IREDELL COUNTY HEALTH DEPARTMENT - *ENVIRONMENTAL HEALTH* ☐ STATESVILLE OFFICE 704-878-5305 ☑ MOORESVILLE OFFICE 704-664-5281

IMPROVEMENT PERMIT / AUTHORIZATION TO CONSTRUCT / OPERATION PERMIT / EXISTING SYSTEM INSPECTION

PERMIT # 169105 PIN # 4658-14-1301 DATE 1-3-12

PERMIT # Repair 174248 PIN # 4658141301 DATE 6-29-2012

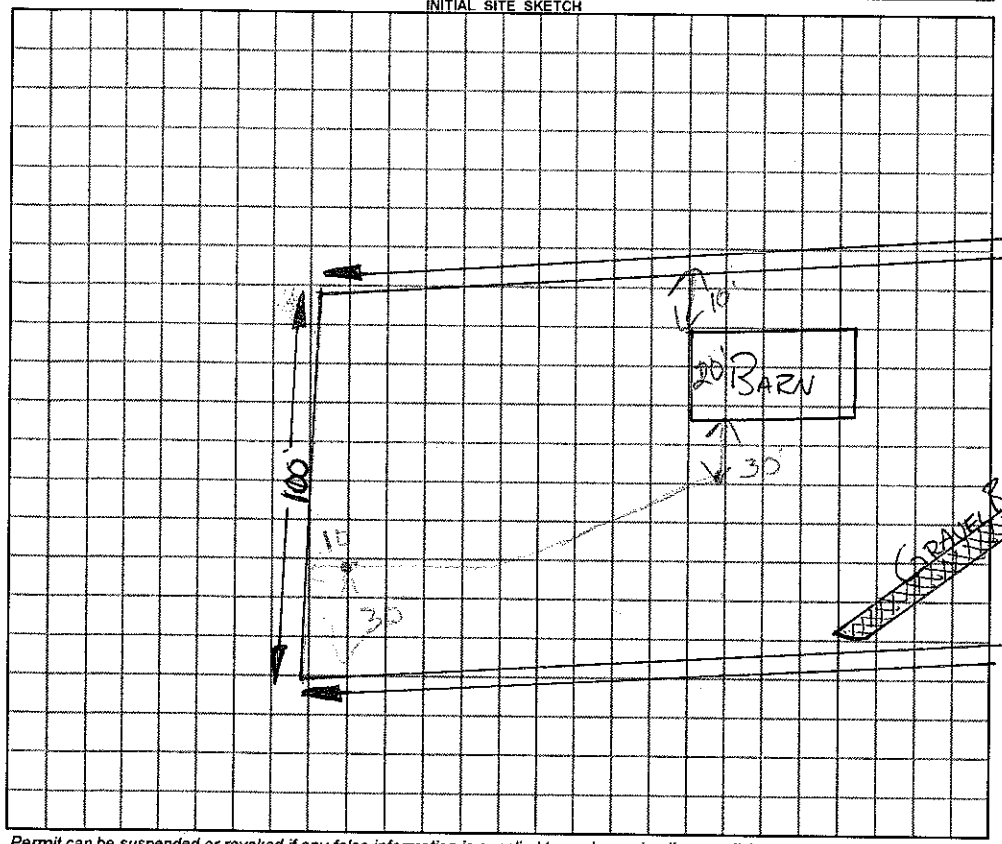
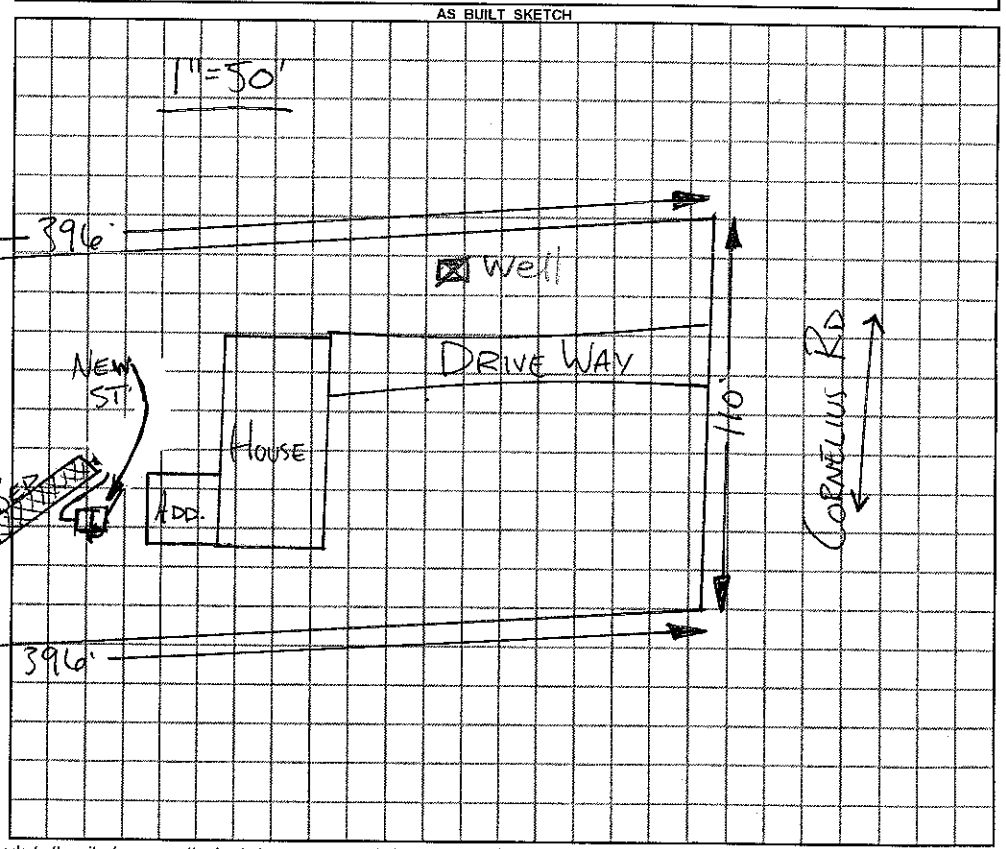
Comments / Conditions ① INSTALL NEW TANK AS SHOWN

② RECOMEND PUMP, CRUSH & FILL OLD TANK

REMOVING ONE BEDROOM & ADDING ANOTHER

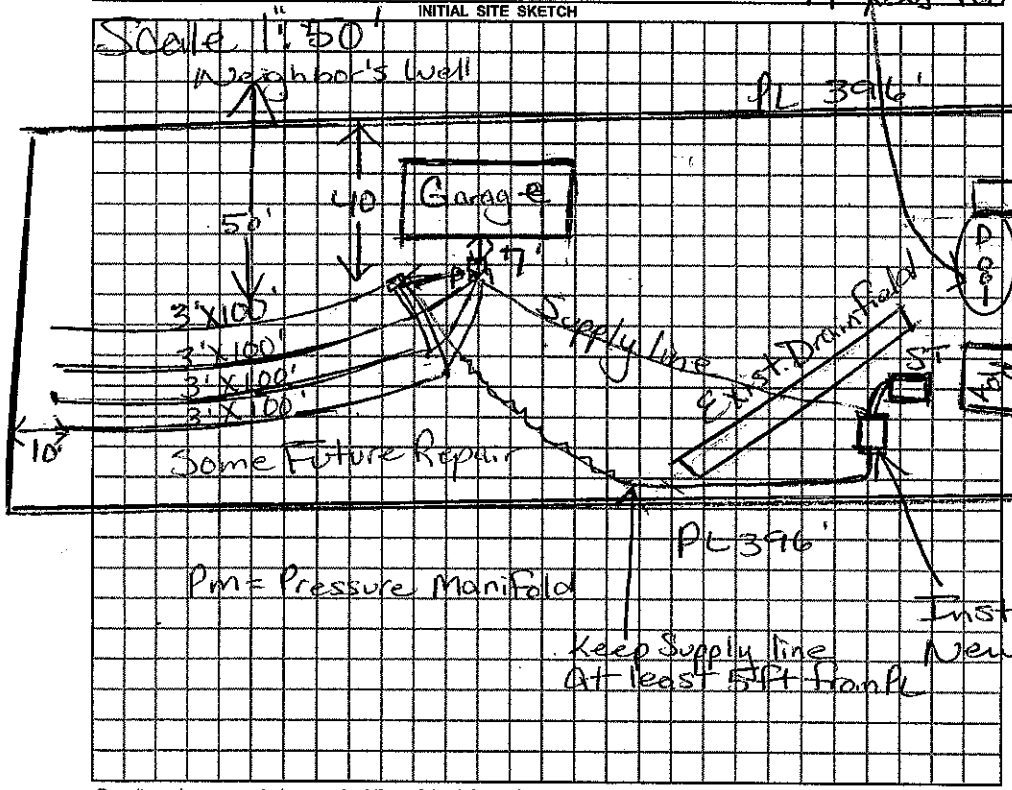
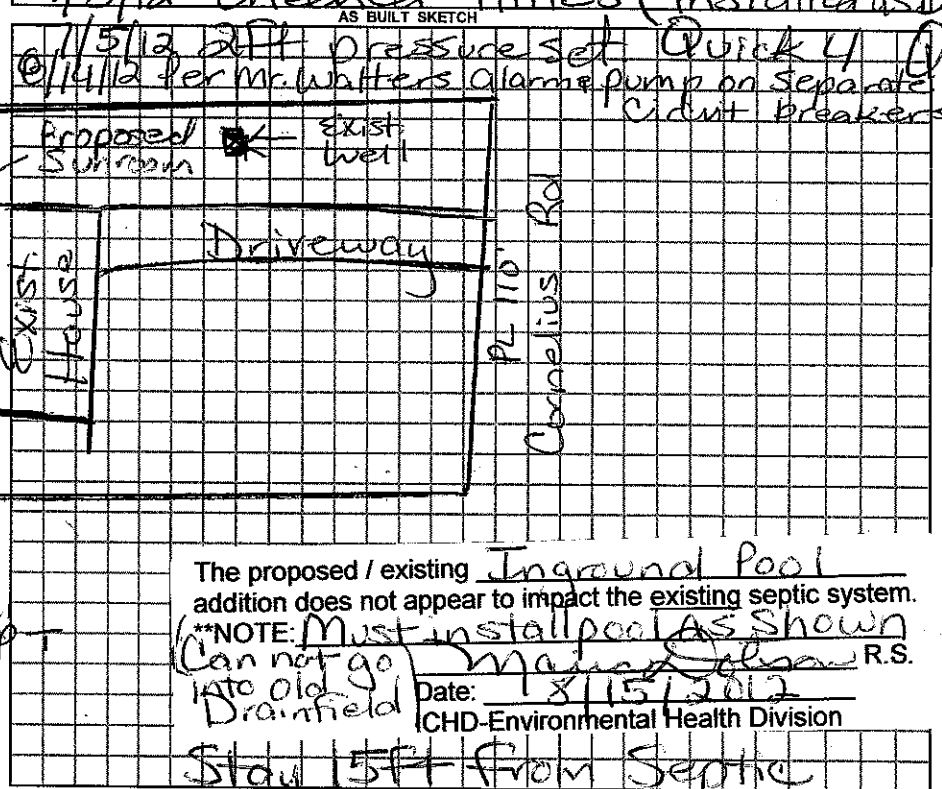
Comments / Conditions: Keep Septic System at least 5ft from PL & 50' from any well

Comments / Conditions: OK to install in 3 lines @ 133Ft ea. Divert Storm/Surface water Away from ST & PT

7/3/12 Checked 4 lines (installed as Drawn

8/14/12 2Hp Pressure set Quick 4 Quick 4 per Mr. Walters alarm & pump on separate Cidcuit breakers

The proposed / existing Inground Pool addition does not appear to impact the existing septic system.

**NOTE: Must install pool AS Shown Can not go into old Drainfield

Stay 15Ft from Septic

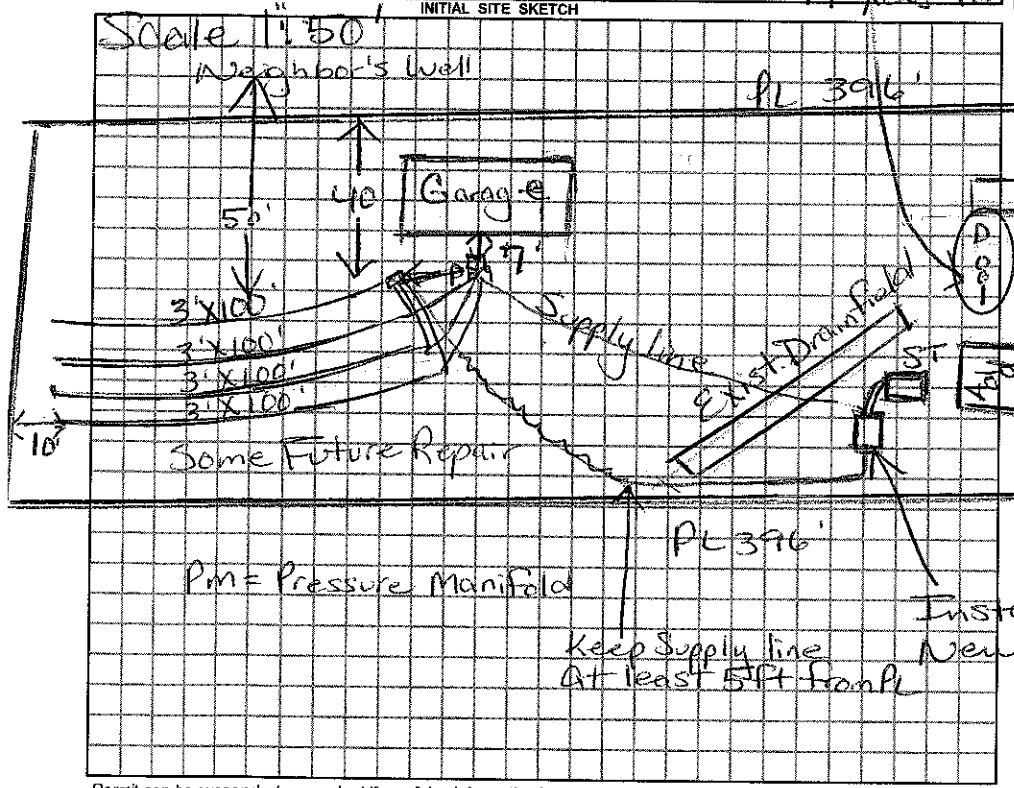
Comments / Conditions Keep Septic System at least 5ft from PL & 50' from any well 14'X28' Pool

Comments / Conditions ACK to install in 3 lines @ 133Ft ea. Direct Storm/Surface water away from S.F & P.T 7/3/12 Checked 4 lines (installed as Drawn) 1/5/12 2Hp pressure set Quick 4 Quick 4 @ 1/4/12 per Mr. Walters alarm & pump on Separate Circuit breakers

The proposed / existing Sunroom addition does not appear to impact the existing septic system.

**NOTE: Any Building must be at least 5Ft from Septic
